Technical Service Bulletin

TSB # - 00018_R1
Date - 08/10/16

- Replacement of SC ECU (P/N 6500073) with Omex ECU (P/N 6500045)

- Commando 961 Dual Seat only, manufactured between Mid 2012 and Dec 2015

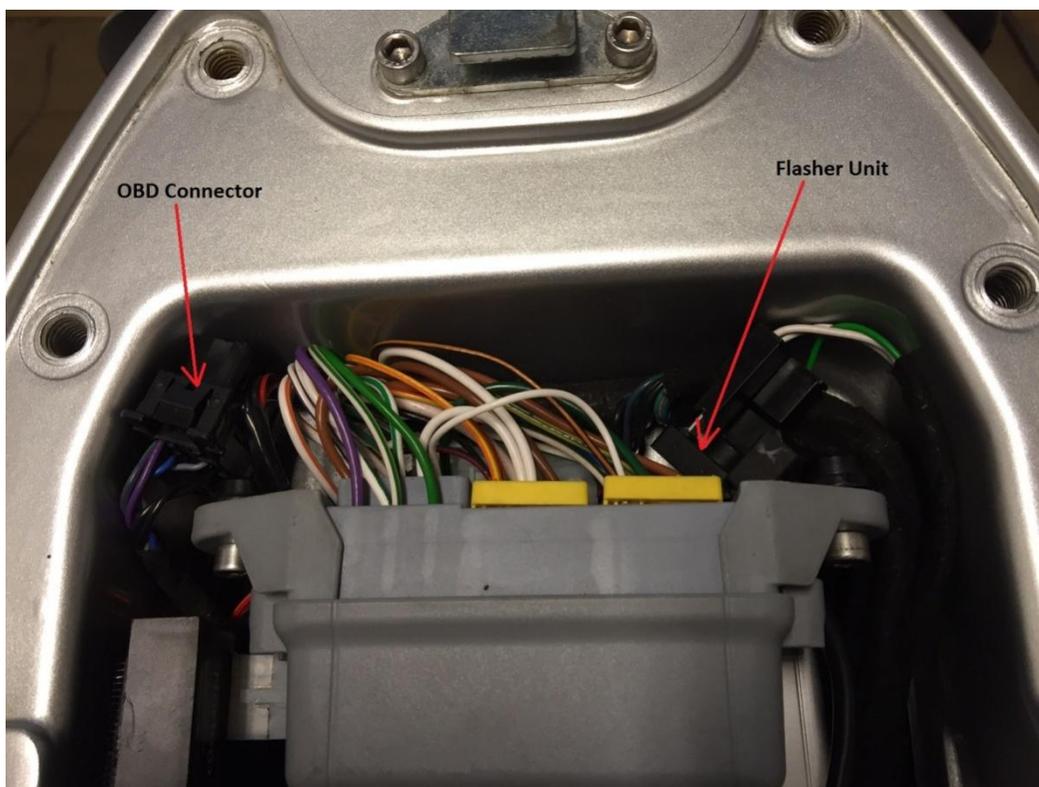
4. Disconnect SC ECU (P/N 6500073) from harness by gently levering up locking tab on the connector. SC ECU no longer required (please return to Norton Motorcycles UK)
5. Replace large indicator flasher unit with smaller unit (P/N 6500065) , place smaller unit in L/H rear corner of the tail unit. Also relocate OBD port to R/H rear corner of the tail unit. The OBD port is now redundant and the large indicator flasher unit is also no longer required.

******* WARNING : OBD PORT CONTAINS LIVE WIRE TO BATTERY 12V TERMINAL, IF DISCONNECTED ENSURE WIRE IS PROPERLY INSULATED. *******

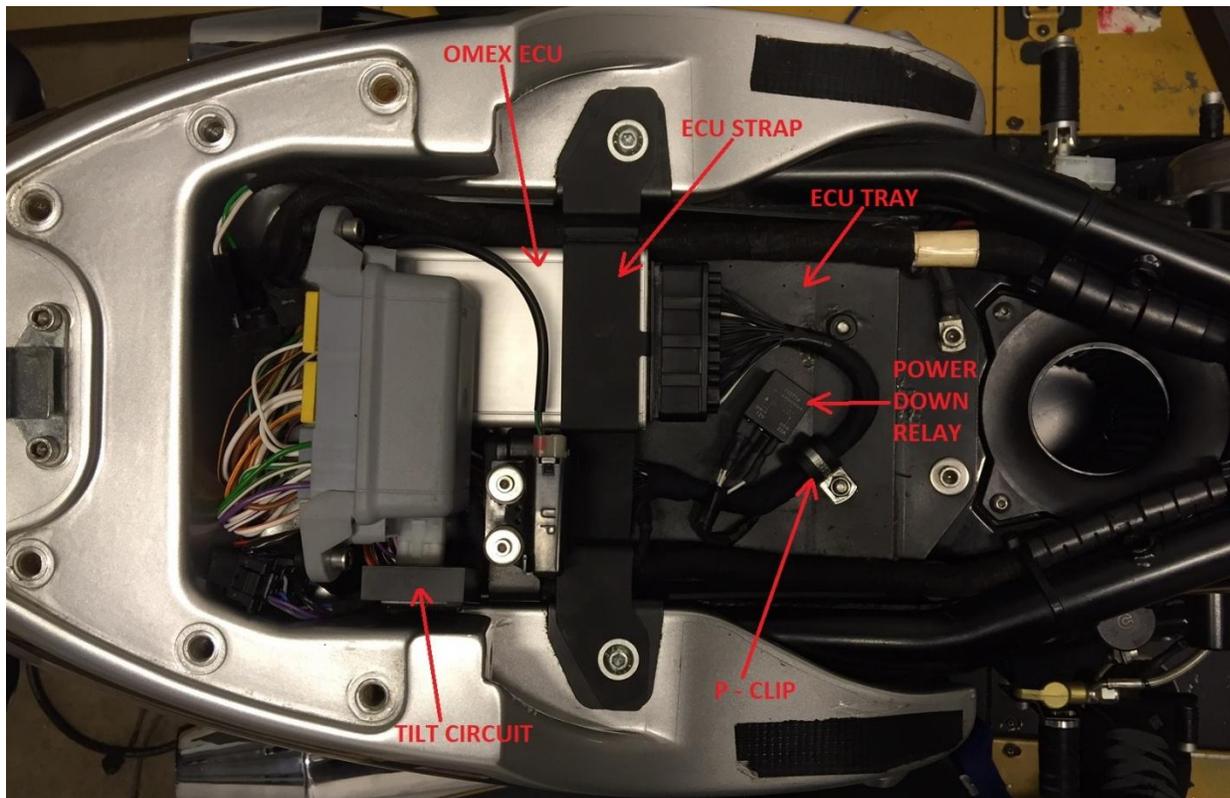
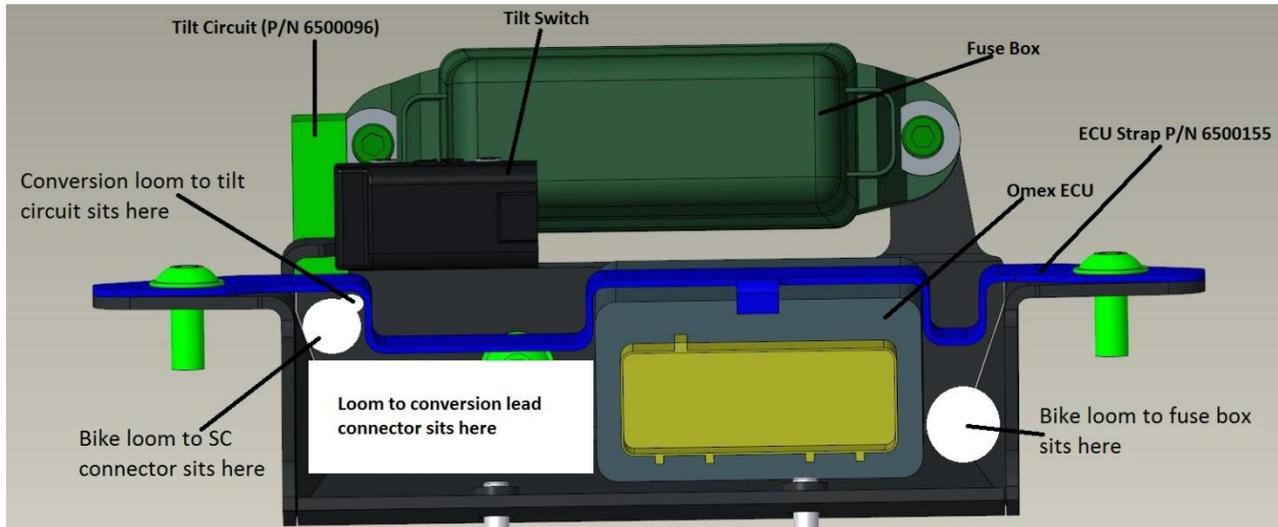
6. Take conversion loom (P/N 6500157) and connect together the Omex ECU (P/N 6500045), the bike loom and the tilt circuit (P/N 6500096).
7. Re connect battery earth terminal.
8. Follow instructions in TSB 00017 to update the ECU with the correct calibration to suit the bike and exhausts.
9. Using ECU strap (P/N 6500155) secure in place the Omex ECU and conversion lead to loom connector as per pictures below. Be careful not to place loom against sharp edges that could rub through insulation and cause short circuit. Dual lock the loom to conversion lead connector onto the ECU tray.
10. Secure tilt circuit with dual lock to the side wall of the dual seat tail unit as shown in below pictures.

11. Replace M6 x 16mm cap head bolt with M6 x 25mm bolt then secure conversion loom with P clip using a nylock nut to hold in place the P clip (shown in above picture).
12. Dual lock the power down relay to the ECU tray to secure in place (shown in above picture).
13. Refit fuel tank (ensuring fuel line is also reconnected) and cycle the ignition key on to off to on again twice, with a 10 second pause between off and on. This will allow the idle air motor to reset to its new position.
14. Start the bike and check for correct operation.
15. Refit pillion seat and rider seat
16. It is advised at this point that a short test ride should be undertaken to ensure correct function of the newly installed ECU.
